Date: 2012-01-10

Engineering Change Request – Class I

Upgrade of TCDQ Collimator

Figure 2 – Proposed layout of the TCDQ system for 4L6.B2 in RA63 (top) and 4R6.B1 in RA67 (bottom).

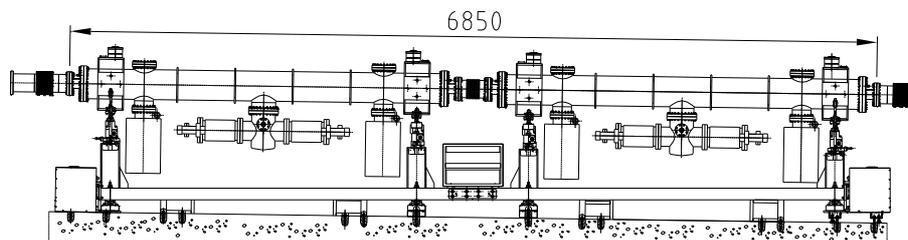
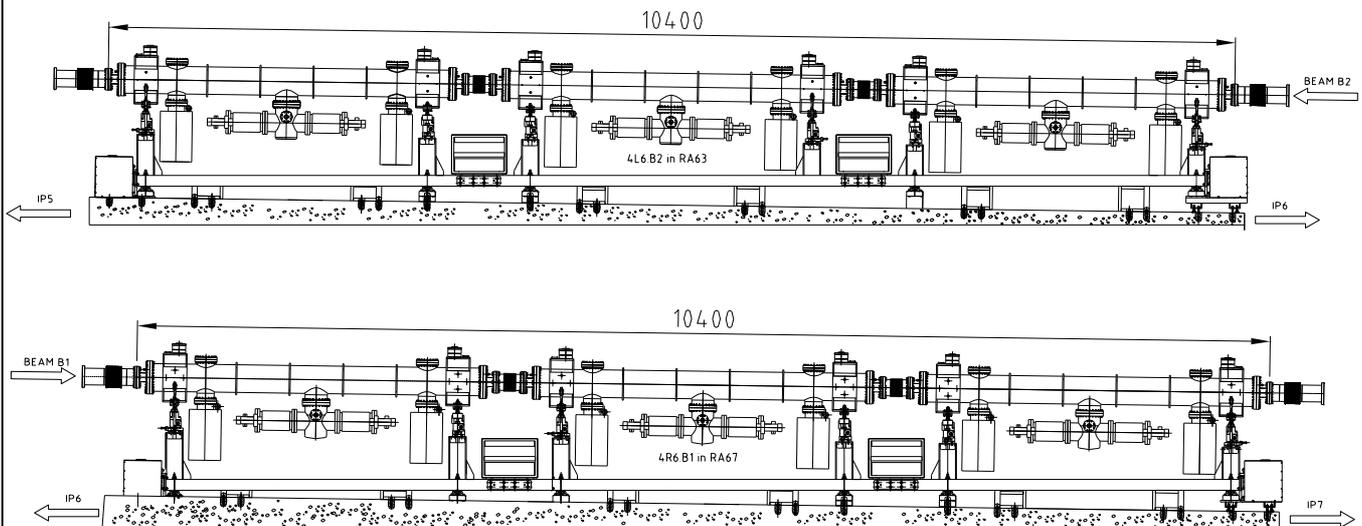
Currently the TCDQ consists of a 2 tank system with a total length 6.85 m, as shown in Figure 1, excluding the VMTAB large displacement bellows. The absorber length is 6.0 m of graphite. This engineering change request proposes to modify this to a 3 tank system with a total length 10.40 m, as shown in Figure 2, with 9.0 m absorber length of carbon-composite.

Figure 3 – Section through the VMTAB bellows showing the racetrack to circular transition and RF contact fingers.

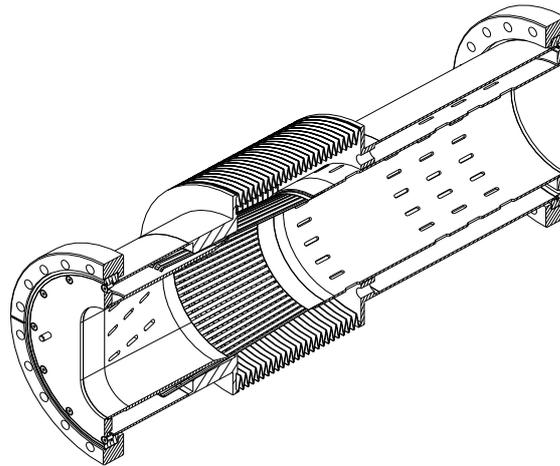
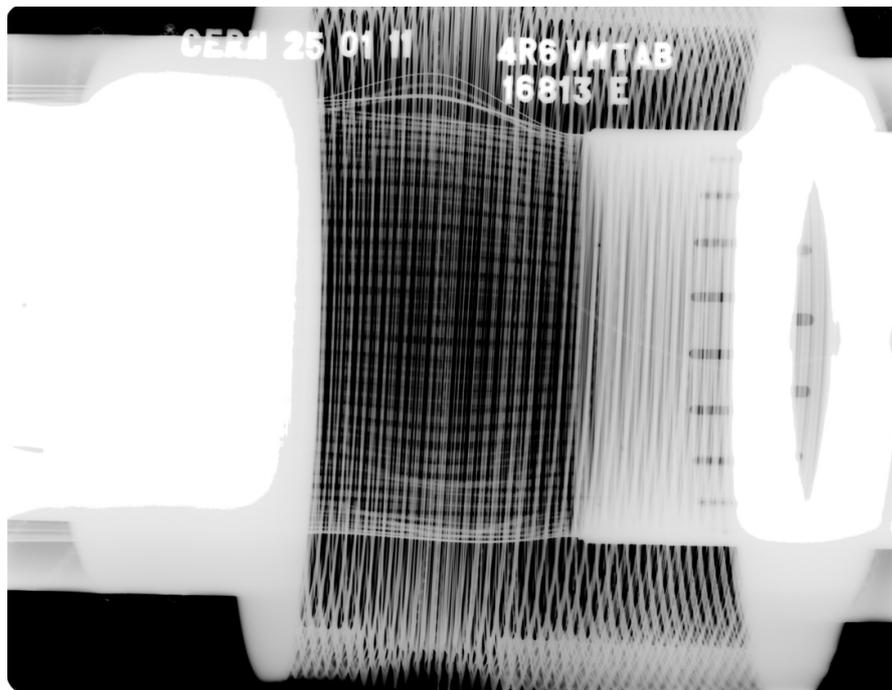
It is also planned to build and install new VMTAB bellows with an improved design which have less friction during operation and do not have the operational problem of bulging contact fingers as observed in the current design. This will reduce wear on mechanical components, improve positioning accuracy, reduce risk of a vacuum leak and reduce the risk of an aperture limitation for the circulating or extracted beam.

The TCDQ system is connected to the vacuum chambers by 2 VMTAB bellows, which include impedance shielding and allow a displacement of ± 20 mm, as illustrated in Figure 3. These bellows also function as transition from the TCDQ racetrack shaped aperture to the 110 mm circular aperture of the LHC vacuum chambers. To allow the required ± 20 mm movement of the TCDQ girder, long RF contact fingers have been used to assure proper impedance shielding. However, due to the stretched length, these fingers have shown to be prone to bulge out during installation or operation, see Figure 4. It is recommended to build and install new bellows with an improved design to avoid this problem in the future, while at the same time reducing the present large force needed to offset the bellows.

Figure 5 – Integration of the current TCDQ situation in 4L6, showing the possible impact on the BPMSB and TCSG positions. The mirror image applies in 4R6.

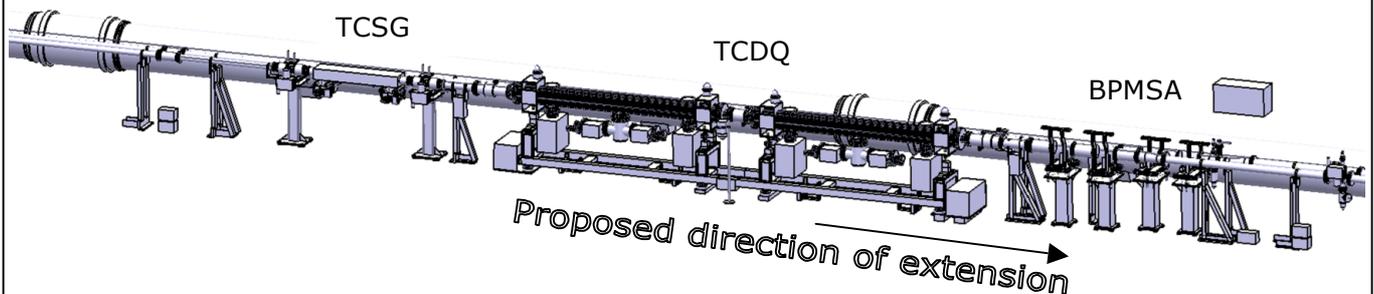
It is proposed to extend the TCDQ structure in upstream direction. Depending on the outcome of the integration studies, the BPMSA and BPMSB monitors have to be moved in order to create space for the extended length of the TCDQ system, as shown in Figure 5. The work related to this change (integration, mechanical arrangement and cabling) must be evaluated. Nevertheless, the impact should remain small since a change of BPM aperture will not be necessary and limited to moving and re-cabling of the systems.

Depending on the outcome of the integration studies, the TCSG collimator possibly has to be moved in order to create space for the extended length of the TCDQ system, as shown in Figure 5. It should be noted that this will be avoided if possible, since it is proposed to extend the TCDQ structure in upstream direction.
